MATERIAL		FINISH		ISSUE	W A S	DATE	APPR.
UNLESS OTHERWISE SPECIFIED DECIMAL DIMENSIONS TO BE ±.		FRACTIONAL DIMENSIONS TO BE ±		ANGLES TO BE ±		DATE 9-27-68	
<b>DUKANE</b> Corporation ESTABLISHED 1922 ST. CHARLES, ILLINOIS U.S.A.		SCHEMATIC DIAGRAM MODEL 110-964B 15 WATT PCB AMPLIFIER		SCALE	APP'D. <i>[Signature]</i>	NO. 190-1662 - 00	
DRAWN <i>[Signature]</i>		CHECKED		ENGR. <i>[Signature]</i>		ISSUE

# REVISED REPAIR PARTS AND PRICE LISTS

NO. 110-964

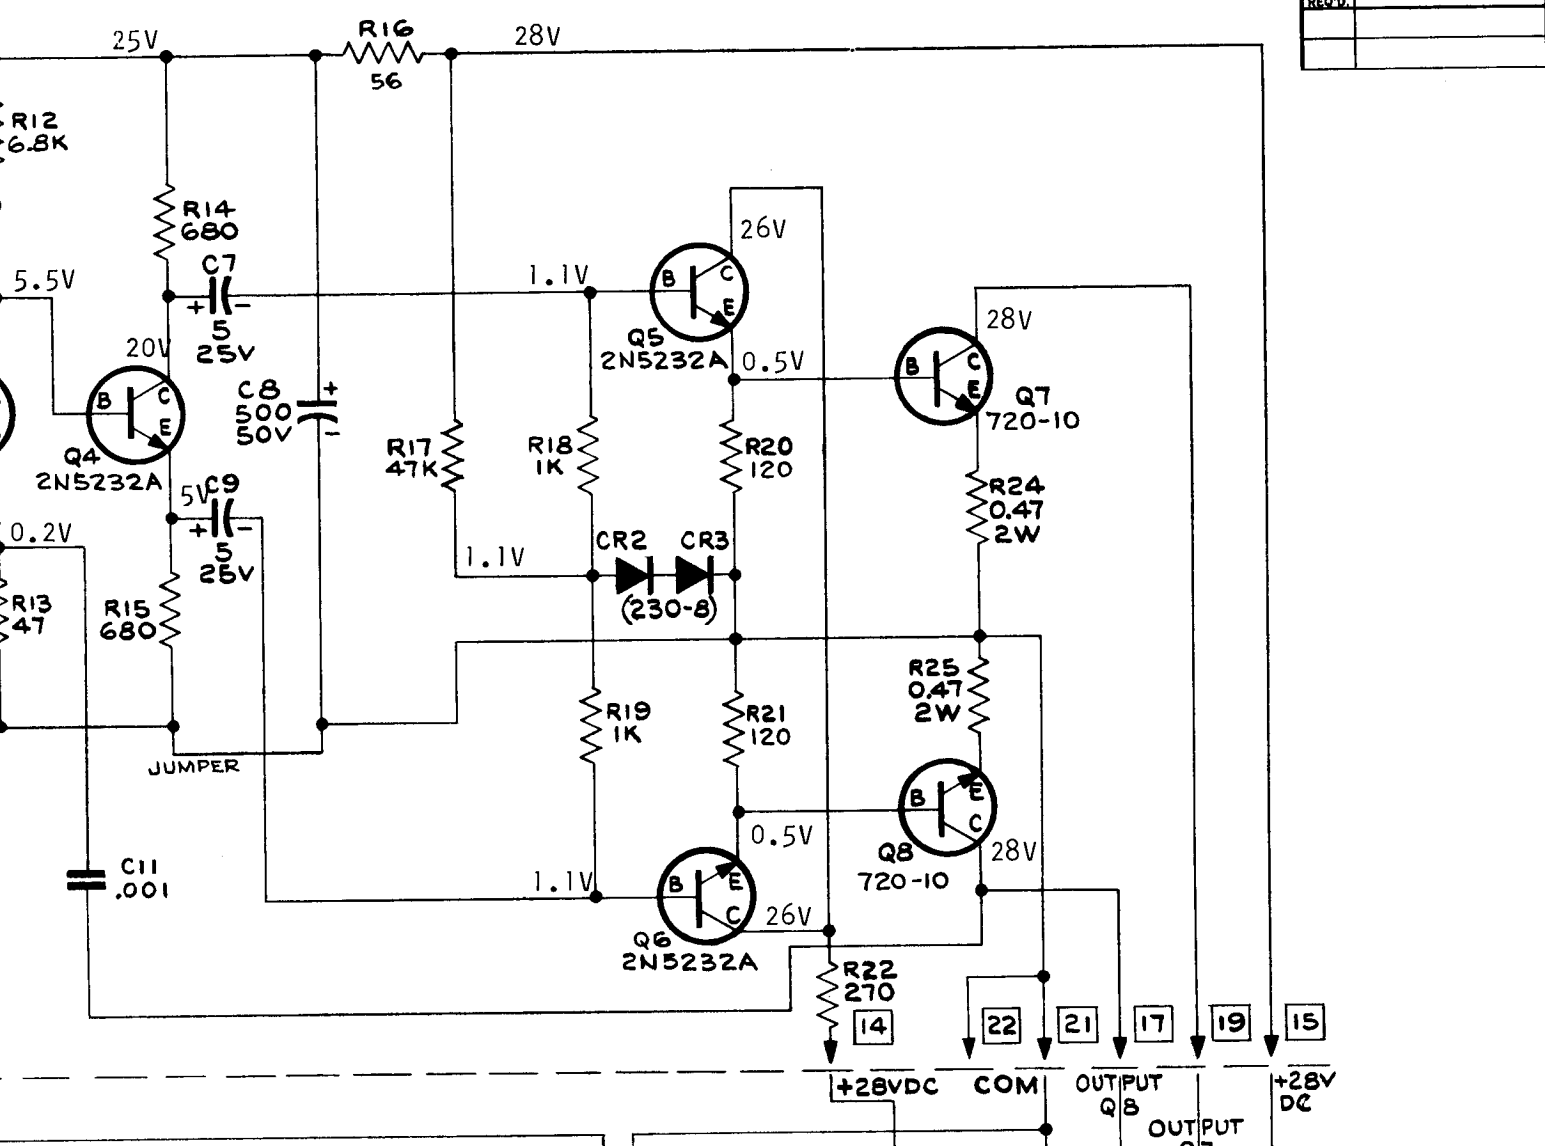
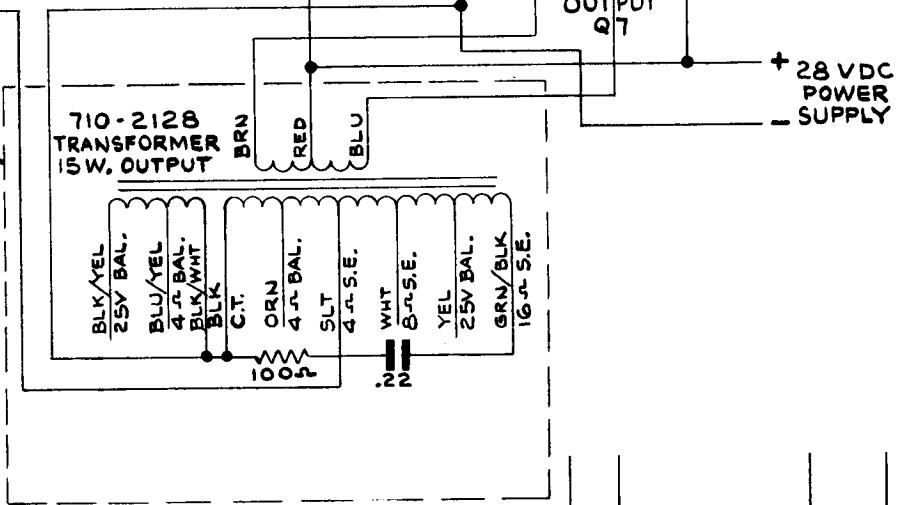
LEGEND	DESCRIPTION	PART NO.	*PRICE	SEE NOTE
Rev. -01 & -02	Foil contact #22 added and connected to #21 (COM); C10 was 680 pF.			
C10	Capacitor, 470 pF, 500 WVDC	199-1009-471	.10	1.
Rev. -02	Q1, Q3, Q4, Q5 and Q6 changed.			
Q1, Q3, Q4, Q5, Q6	Transistor, type 2N5232A	720-2N5232A	.50	4.
Rev. -03	C5 and C6 are changed.			
C5	Capacitor, 100 $\mu$ F, 25 WVDC; electrolytic	199-2021-107	.90	3.
C6	" , 470 pF, 500 WVDC	199-1009-471	.10	3.
PLEASE discard BLUE sheets through 404-473.01.

1. IMPROVED VERSION
2. ADDED COMPONENT
3. NEW VALUE REQUIRED
4. OLD PART NOT AVAILABLE
